Wiltshire Council Planning Consultation Response

Jocelyn Sage
Senior Conservation Officer
Wiltshire Council Conservation
(South/West)

Application No: PL/2025/09342
Change of use of first floor level from office space to residential and conversion to 2no residential apartments.
38B Market Place, Wiltshire, BA12 9AN

PHOTO OF EXISTING BUILDING FRONTAGE

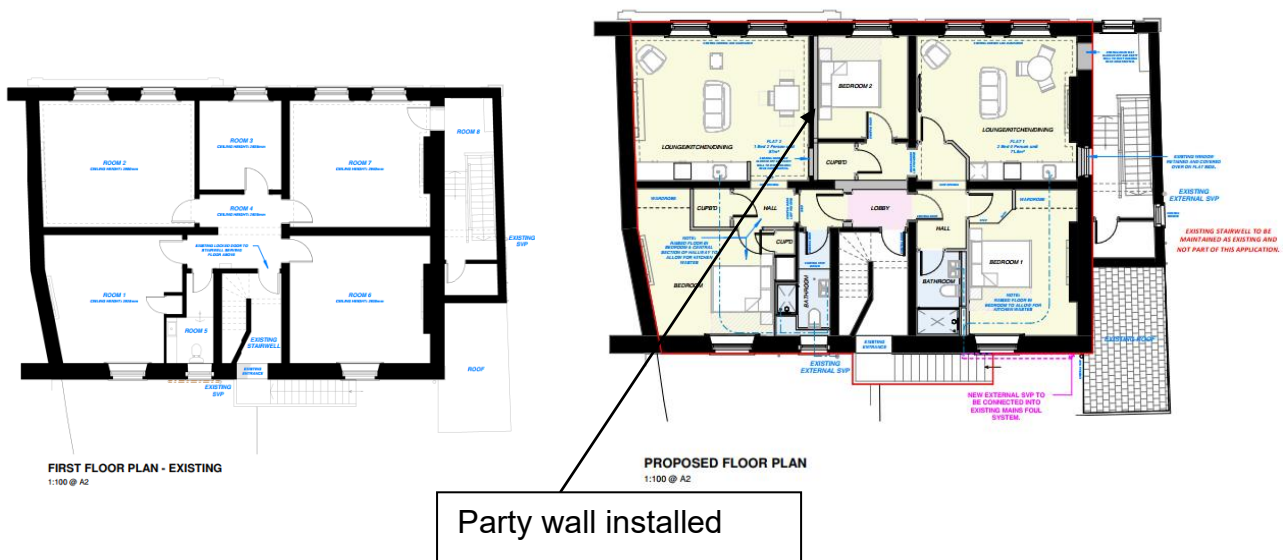
In terms of the elevations, the front (street facing elevation) is particularly pleasing with its sash windows with fine glazing bars and ashlar stone, but the rubblestone rear is attractive too, particularly the arched doorway (presumably formerly an arched staircase window?).

Negative elements are the treatment of the rear 'arched doorway'. The small PVCu second floor window; the pipework across the rear; the modern red brick external staircase and a roof of what appears to be concrete tiles?

The two proposed first floor flats would be accessed via the red brick staircase at the rear. The elevations say '*all building externals to remain as existing*'. This is a missed opportunity for enhancing the rear elevation – for example, the existing rear first floor door is not of historic interest and could be replaced with something more appropriate and the porch removed.

The only exception to the 'no change' statement is a new soil pipe which tracks across the back of the house, cutting across the string course in a crude fashion, replicating the existing ungainly pipework serving the second floor. **This is a harmful alteration.**

EXISTING INTERNAL DETAILS

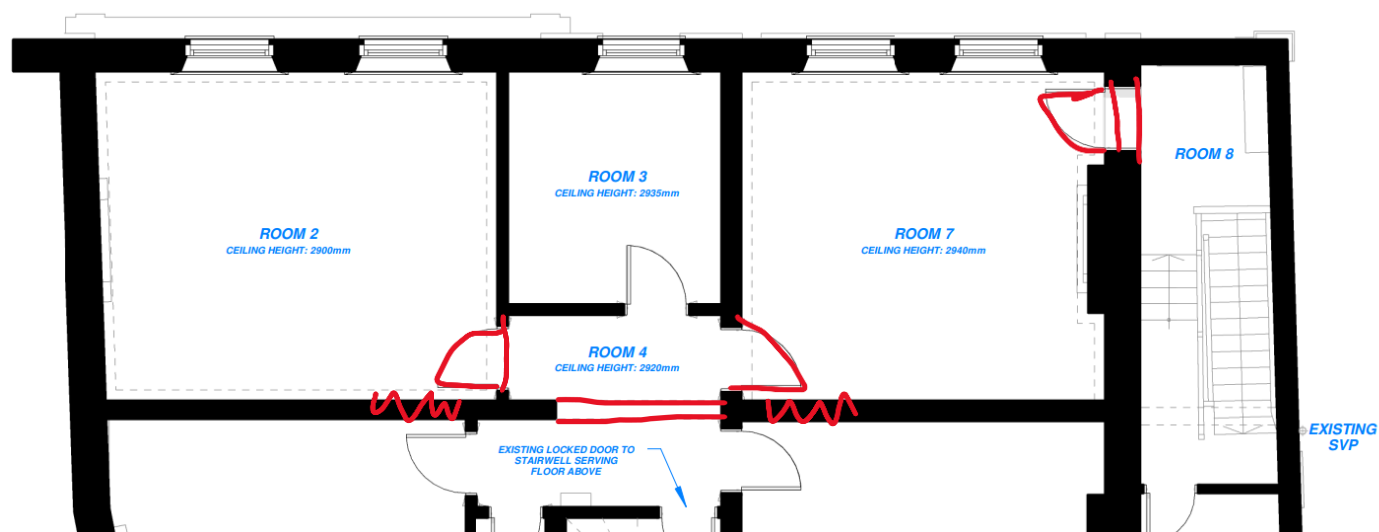
Focusing on the front three rooms (room 2, 3 and 7). The existing plan has a dotted line around the perimeter of rooms 2 and 7. Having visited the site today, this I believe indicates an existing cornice. Rooms 2 and 7 have fireplaces. The D&A&Heritage statement has two photos but doesn't say which rooms they are located in.

Room 4 is the lobby with a wide decorative arched opening (see above Fig.9). There is a door each into room 2 and room 3. Most of the doors are the original 6 panelled doors. Room 7 has two doors – one accessing the side stairwell (the stairwell being a later addition which I am guessing is likely Victorian and would correspond with other Victorian features at first floor).

There is no mention of the construction of the floors in the heritage statement and most of the rooms are carpeted. However, at least one room has no carpet and plyboard is evident. I recommend that some opening up/revealing works are undertaken to establish the floor structure.

Proposals – piano nobile

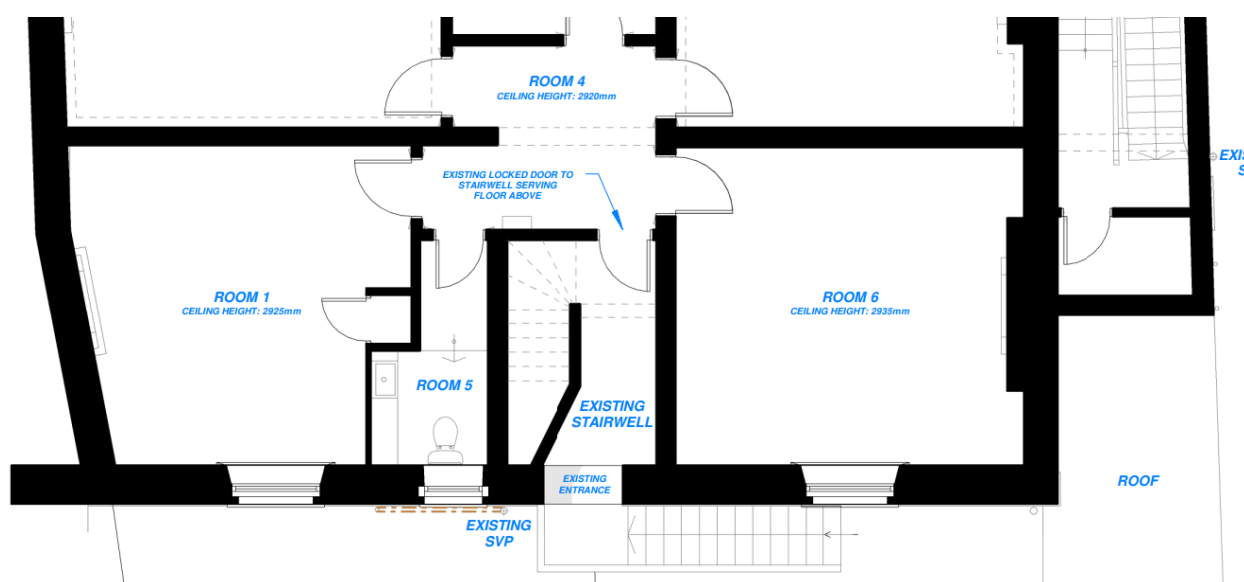
Room 2 (flat 2) – lounge/kitchen diner. Existing door blocked with the associated impact on the historic door and decorative architrave and a new opening would be formed in rear wall. No details on how this would be treated – either the blocking or the new doorway.

The proposals would result in the erosion of the floorplan as the existing central circulation space would be eroded. There is also the issue of services. And would there need to be fire separation from the commercial ground floor unit? I don't think this is mentioned.

New party wall inserted within lobby/room 3¹. This room is relatively plain (it has a picture rail that appears to be a much later addition).

The hall archway is infilled and a cupboard formed. There are no details about how the archway would be filled ie would the feature be entirely removed and flush plasterboard walls installed? Clearly the proposal would have a significant harmful impact on the appreciation of this attractive decorative feature.

Room 7 (flat 1). A lobby is formed which uncomfortably impacts on the space. The existing door (which is original) is removed. The cornice within room 7 is incomplete in this room (only on 3 sides, not the rear wall) so the lobby wouldn't necessarily have an adverse impact on this feature. The proposals show the existing side window infilled but not how (nor indeed why). A new opening would be formed in the rear wall, setting aside the issue of loss of historic fabric and erosion of the plan form, no elevation details are provided.

Flat 2 (LHS) = would be accessed via a lobby in front of the infilled decorative arch. The plans say that the existing stairwell door is retained, although this is a modern unattractive bit of joinery. A new door leads into Flat 2. There is no mention on whether this needs to be a fire door (but I would assume so) nor what it might look like.

In the rear bedroom, there is an existing historic cupboard which is not shown on the existing plans. It should be. The room is generous enough that it can probably sustain some subdivision but the proposed cupboard should be reconsidered if the historic cupboard is to be retained (which it should be).

The significant issue though is the raised floor level to accommodate the proposed services. This too is replicated in the rear room on the RHS. There are no details about the construction of the existing floor for a start. Then there is the issue of the impact on the fireplace and hearth, skirting boards, doors and door architraves etc. This needs to be carefully considered and precisely articulated with detailed section drawings – all currently missing.

Furthermore, when I visited with the owner he talked about a suspended ceiling, presumably to create fire separation (and noise) from the second floor flats. There is no mention of this on the plans and this would certainly impact the cornices in rooms 2 and 7, and perhaps more significantly, the tops of the window architraves. This too needs to be carefully considered and detailed (fortunately there are no decorative ceilings, ceiling roses etc).

Room 6 (flat 1) – significant subdivision of the space although it would appear large enough to accommodate it?

Again the issue of a raised floor installed (ie impact on fireplace, skirting boards, proportions etc). No elevational details supplied.

Also, a note on the drawing says 'existing door' from lobby into the hall but surely this would need to be upgraded?

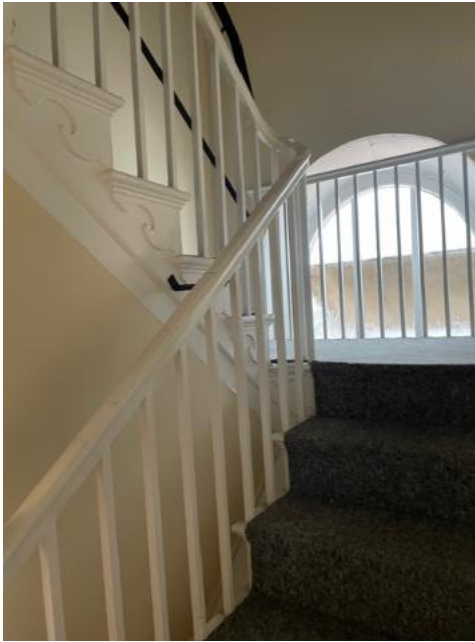
Room 6 with plyboard floor
